**Monks Orchard Residents' Association
Planning**

Reference	19/04705/FUL
Application Received	Wed 02 Oct 2019
Application Validated	Wed 02 Oct 2019
Amended Drawings:	12th December 2019
Address	16-18 Ash Tree Close Croydon CR0 7SR
Proposal	Demolition of the existing dwellings. Erection of 8 x 3-bed semi-detached dwellings with associated access, parking, refuse and cycle stores.
Case Officer:	Wayne Spencer
Ext Consultation Close:	28th December 2019
Determination:	Wed 27 Nov 2019

This is an **updated representation** as a result of **amended drawings** issued on **12th December 2019** with an extension to the consultation until **28th December 2019**. Please consider this representation to replace our earlier submission of **20th October 2019**.

Amended Swept Path Egress Diagrams:

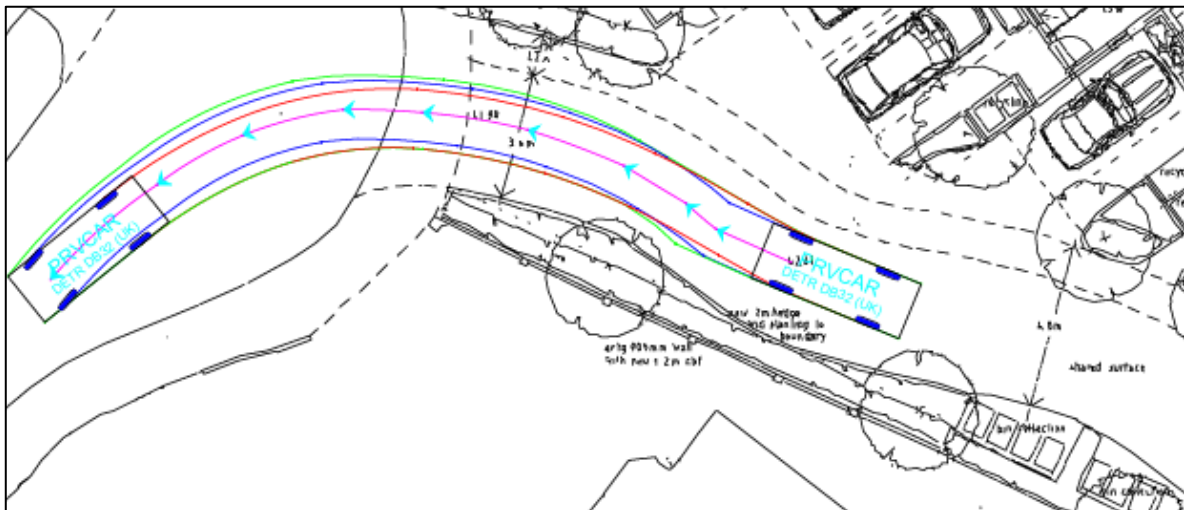
The amended “Swept Path Diagrams” provided with the documents associated with the proposed development give an indication of the entrance to park in the Plot Bays in a forward gear and also the swept paths necessary to exit the plot bays and change into a forward gear to exit safely across the access footpath and drop-kerb into Ash Tree Close. An analysis of these swept path manoeuvres are given below.

Any vehicle (delivery vehicle etc) which accesses the new driveway in a **forward gear** and finds all parking bays full, has **NO turning head** to allow exiting in a **forward gear** across the footpath of **Ash Tree Close**. This results in an **extreme safety hazard** to possible pedestrians using the footpath.

The only solution is to **Reverse into the driveway** but that might not be considered by the driver before actually **entering** the driveway and once entered in a forward direction, the driver would have to **reverse** out and may not have a passenger to assist in the manoeuvre **to check it is clear and safe to reverse** out across the footpath of **Ash Tree Close**.

Plot 1 Parking Bay Egress

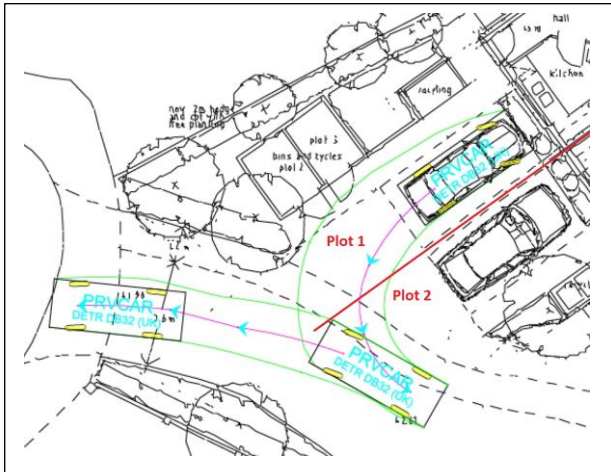
The Swept path diagram for Parking Bay 1 indicates the difficulty exiting the parking bay in reverse gear in order to exit the driveway in a forward gear into Ash Tree Close roadway.

The new swept path diagram for Plot 1 shows that in order to exit, it is necessary to encroach over the curtilage of Plot 2 forecourt and the access footpath which is inappropriate.

The future occupants of Plot 2 would likely object to this necessary manoeuvre for the life of the development as an inconvenience which could cause conflict for the life of the development.

The owner occupier of Plot 2 may wish to erect a boundary fence to extend to the footpath in order to define the curtilage of responsibility and maintenance which would prevent further manoeuvres of egress of a forward parked vehicle from exiting Plot 1 Parking Bay.

Plot 2 Parking Bay Egress

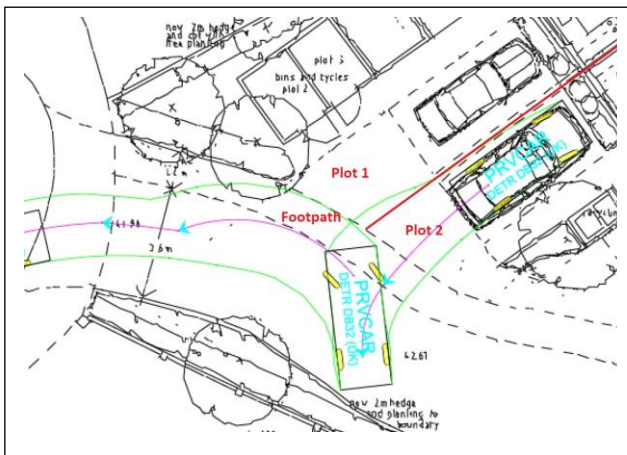
The Swept path diagram for Parking Bay Plot 2 indicates the difficulty exiting parking bay in reverse gear in order to exit the driveway in a forward gear into Ash Tree Close roadway.

The new swept path diagram shows that it is necessary to encroach over the curtilage of Plot 1 Forecourt and then necessary to change into a forward gear and mount the access footpath in front of Plot 1 in order to exit in a forward gear into Ash Tree Close.

The future occupants of Plot 1 would likely object to this necessary manoeuvre for the life of the development as an inconvenience which could cause conflict for the life of the development. The owner occupier of Plot 1 may wish to erect a boundary fence to extend to the footpath in order to define the curtilage of responsibility and maintenance which would prevent further manoeuvres of egress of a forward parked vehicle from exiting Plot 2 Parking Bay.

Plot 3 Parking Bay Egress

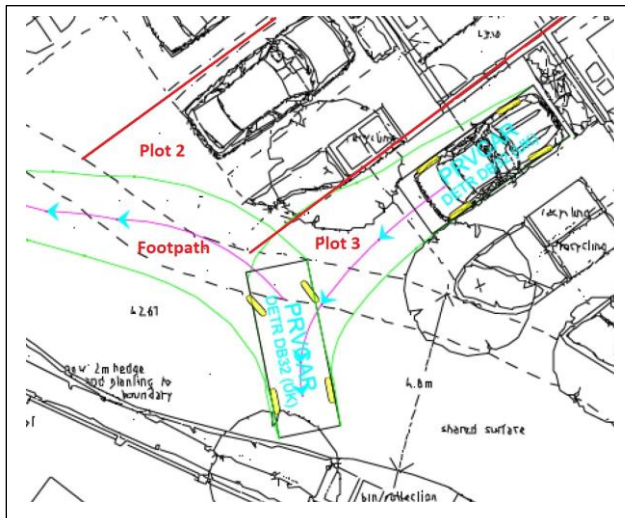
The Swept path diagram for Parking Bay Plot 3 indicates the difficulty exiting parking bay in reverse gear in order to exit the driveway in a forward gear into Ash Tree Close roadway.

The new swept path diagram shows that it is necessary to encroach over the curtilage of Plot 2 Forecourt and then necessary to change into a forward gear and mount the access footpath in front of Plot 2 in order to exit in a forward gear into Ash Tree Close.

The future occupants of Plot 2 would likely object to this necessary manoeuvre for the life of the development as an inconvenience which could cause conflict for the life of the development.

The owner occupier of Plot 2 may wish to erect a boundary fence to extend to the footpath in order to define the curtilage of responsibility and maintenance which would prevent further manoeuvres of egress of a forward parked vehicle from exiting Plot 3 Parking Bay.

Plot 6 Parking Bay Egress

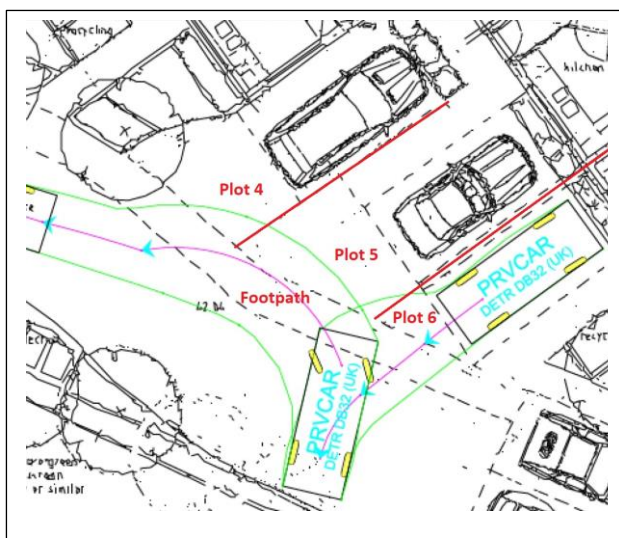
The Swept path diagram for Parking Bay for Plot 6 indicates the difficulty exiting parking bay in reverse gear in order to exit the driveway in a forward gear into Ash Tree Close roadway.

The new swept path diagram shows that it is necessary to encroach over the curtilage of Plot 4 & 5 Forecourt and mount the access footpath in front of Plot 4 & 5 in order to exit in a forward gear into Ash Tree Close. The future occupants of Plots 4 & 5 would likely object to this necessary manoeuvre for the life of the development as an inconvenience which could cause

The owner occupier of Plots 4 or 5 may wish to erect a boundary fence to extend to the footpath in order to define the curtilage of their responsibilities and maintenance which would prevent further manoeuvres of egress of a forward parked vehicle from exiting Plot 6 Parking Bay.

Plot 7 Parking Bay Egress

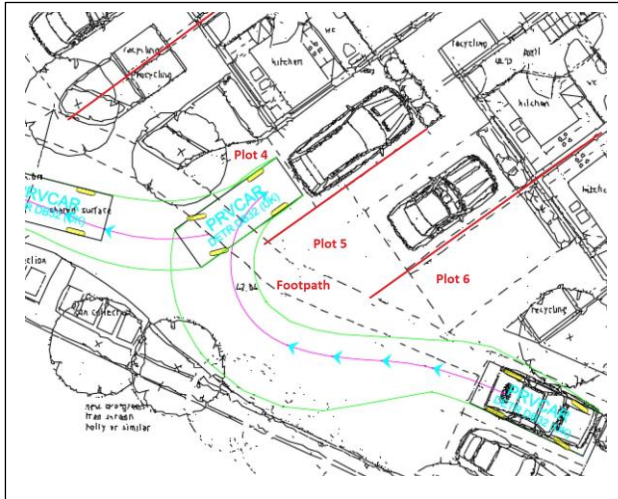
The Swept path diagram for Parking Bay Plot 7 indicates the difficulty exiting parking bay in reverse gear in order to exit the driveway in a forward gear into Ash Tree Close roadway.

The new swept path diagram shows that it is necessary to mount the footpath and encroach into the forecourt within the curtilage of Plot 4 in a reverse gear before engaging a forward gear, mounting the access footpath in front of Plot 4 in order to exit in a forward gear into Ash Tree Close.

Plot 8 Parking Bay Egress

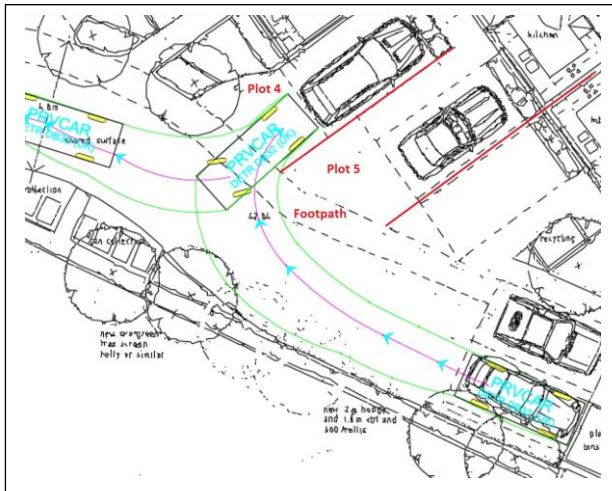
The new swept path diagram shows that it is necessary to mount the footpath and encroach into the forecourt within the curtilage of Plot 4 in a reverse gear before engaging a forward gear, mounting the access footpath in front of Plot 4 in order to exit in a forward gear into Ash Tree Close.

The future occupants of Plot 4 would likely object to this necessary manoeuvre for the life of the development as an inconvenience which could cause conflict for the life of the development.

**There is NO acceptable turning head for vehicles entering the access Drive.
The new swept path diagrams indicate that the parking configuration is incompatible with the configuration of the dwellings and even after revisiting this aspect of the proposal it is NOT possible to enter and exit the parking bays in a smooth operational organised manoeuvre without mounting the footpath and/or encroaching onto the forecourts of other plots, which is totally unacceptable.**

Extent of Flood Risk at proposed development site

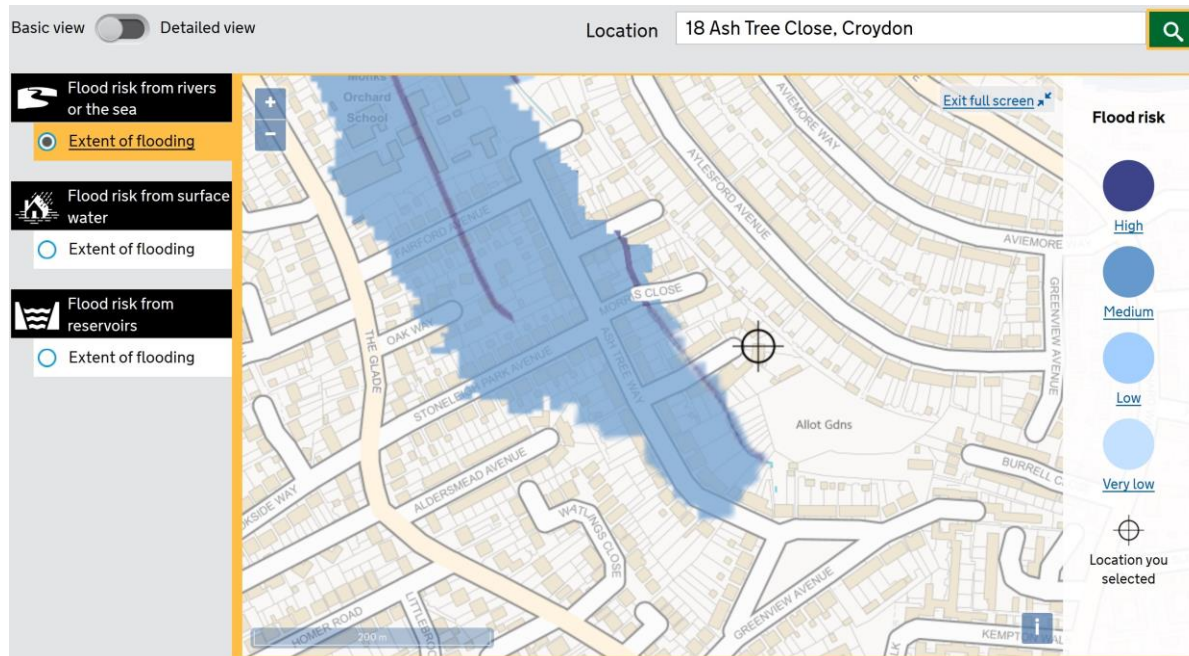
As there are flooding issues in the lower end of Ash Tree Close and Ash Tree Way, any future development planning at this locality would need to take surface water flooding seriously into consideration.
